Notice of design changes to product / packaging label to change of applicable regulation (removal of EAC mark)**[Effective Date]**

[Target Products]

Relays, Switches, Connectors with EAC marking.

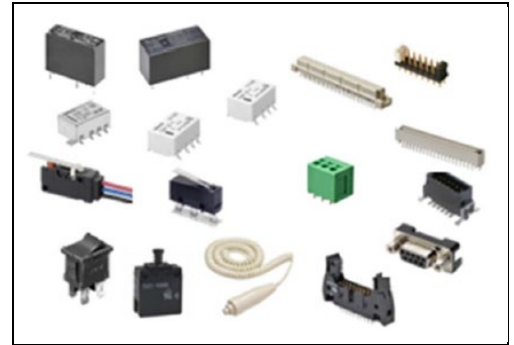
The EAC mark will be removed on the product body/label, packaging label, and/or packaging.

(Some models of Power relays will be removed from the product itself. For other models, due to space restrictions, they have not been stamped on the product itself, so they will only be removed from the packaging label.)

Due to the deletion of the EAC mark, other display positions and sizes may be changed.

Before the change	After the change
<div>■Product body mark With EAC mark</div> <div>■Image of Packing label With EAC mark</div> <div></div>	<div>■Product body mark No EAC mark</div> <div>■Image of Packing label No EAC mark</div> <div></div> <div>Note) Label display may be different from actual label.</div>
